SERVICE BULLETIN
#LO-006

RE: Rear Receiver

MODELS: Little Guy Max & Little Guy Mini Max.

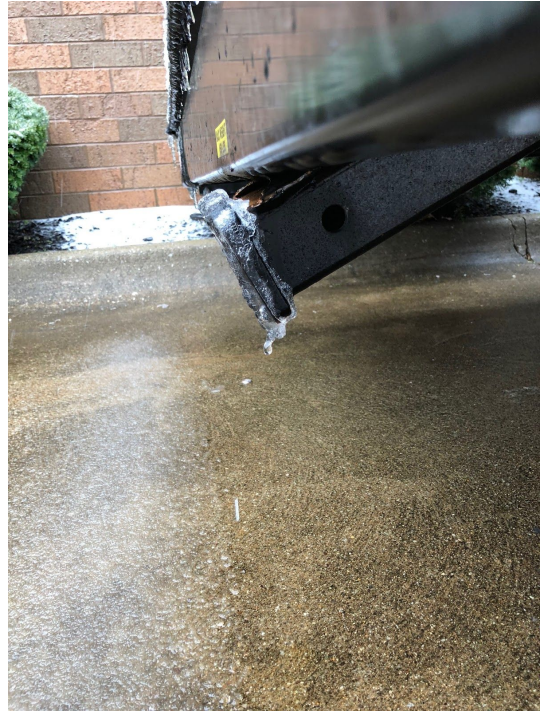
PROBLEM: It is possible for the rear receiver weld to break or bend due to rust or corrosion at the attachment point.

Broken weld on 2nd C channel in from rear bumper

Broken weld forces receiver to bend

CORRECTION: Additional piece(s) can be welded onto the chassis to better support the receiver rack and prevent failure.

**New reinforcement tube welded into C channel for extra support
*This is not the only way to support it, the dealer can support it in a variety of ways**
